**MEMORANDUM**

**RE:** PC# 17-003  
RagingWire Data Centers  
Hamilton Lakes Dr. at Pierce Rd.

**RE:** RagingWire Data Center – Plan Commission Submittal  
Engineering Review #4  
REL# 16-R0675

To: Konstantine Savoy  
From: Michael Lisek *ML*  
Director of Fire Prevention  
Subject: Raging Wire 2019

# Current Design with Village Comments

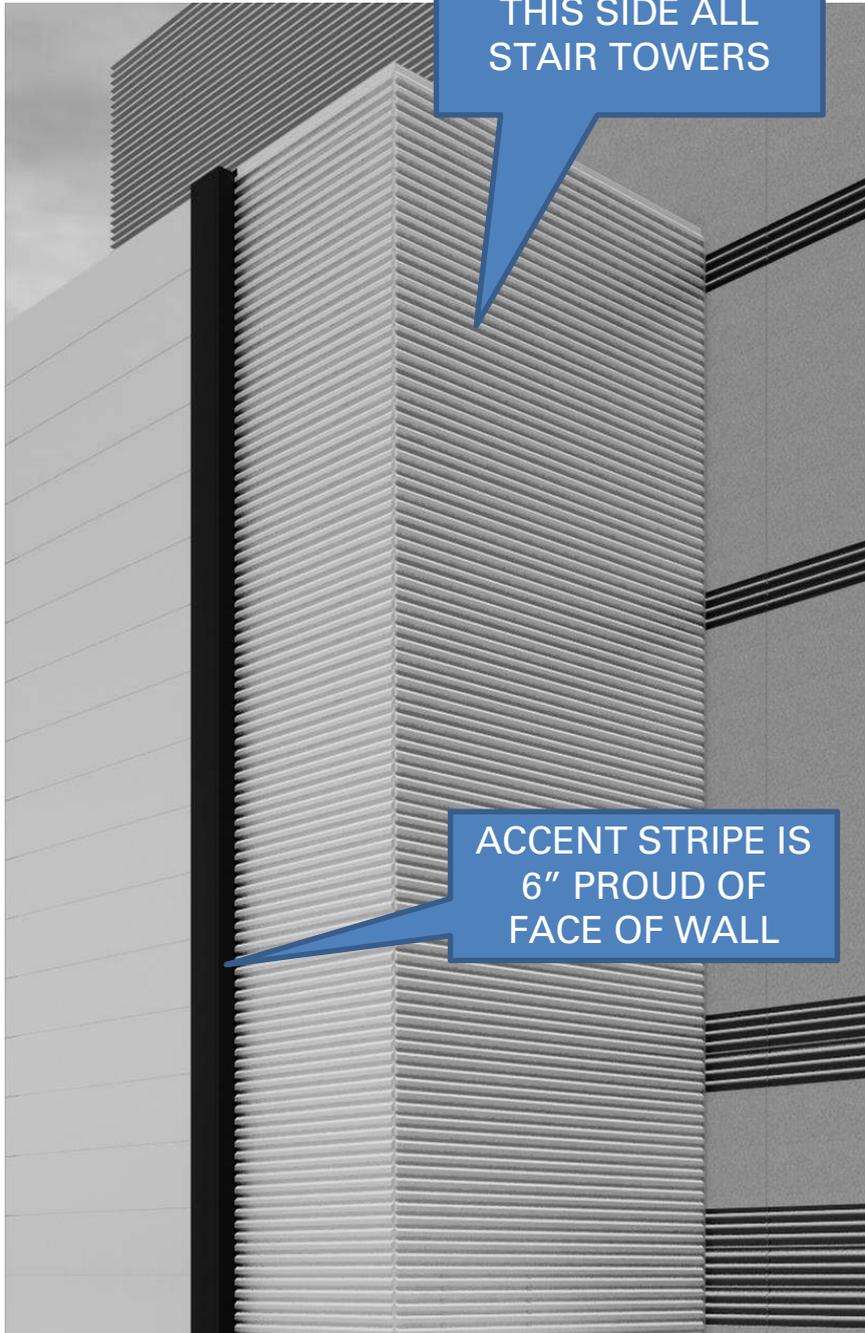
WINDOW  
FRAMES  
MATCH WALL

RIBBED PANELS  
BEHIND FIN'S

ALL SMOOTH  
PANELS IN FIELD  
(NO PATTERN)

ACCENT COLOR &  
STRIPE REMOVES  
THIS SIDE ALL  
STAIR TOWERS

ALL SMOOTH  
PANELS IN FIELD  
(NO PATTERN)

RIBBED PANELS  
THIS SIDE ALL  
STAIR TOWERS

ACCENT STRIPE IS  
6" PROUD OF  
FACE OF WALL

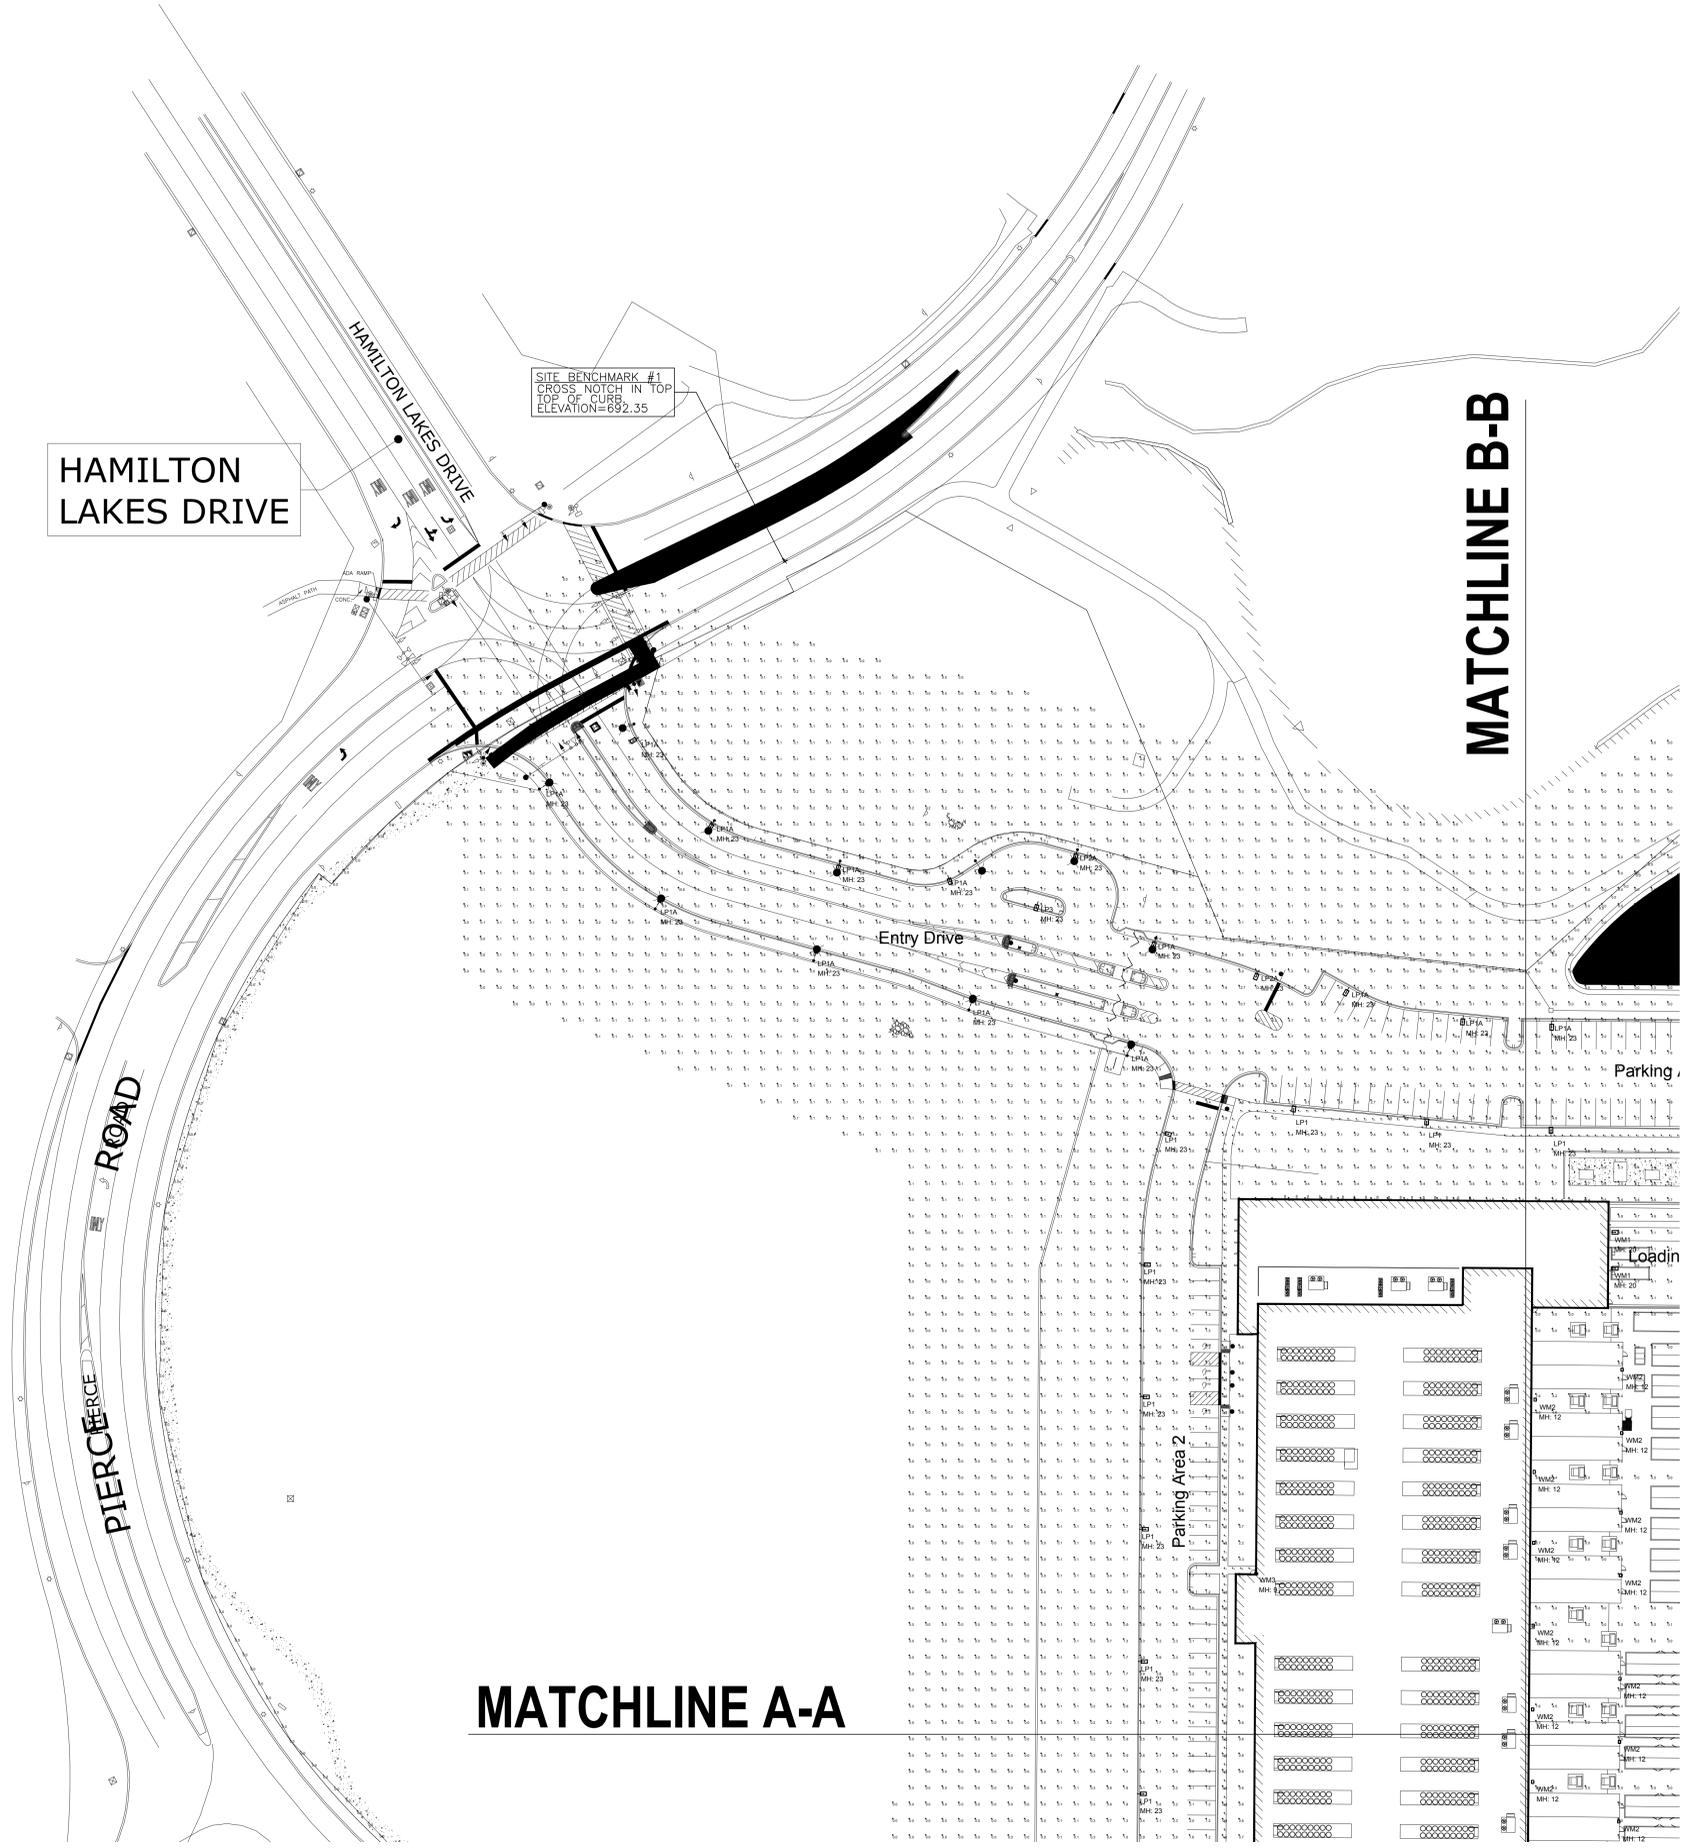
3. The Plat of Subdivision must be revised to include all required access and utility easements.
4. Street trees are to be installed every 50' adjacent to the right-of-way for Lots 3 and 4 where such trees do not already exist.

5. The proposed trail along Lake 5 is being relocated, a 15' easement is shown on the preliminary engineering plans. It shall also be shown on the plat of subdivision. All other proposed easements for utilities shall be added to the plat of subdivision. **All required easements shall be granted by the Final Plat of Subdivision.**
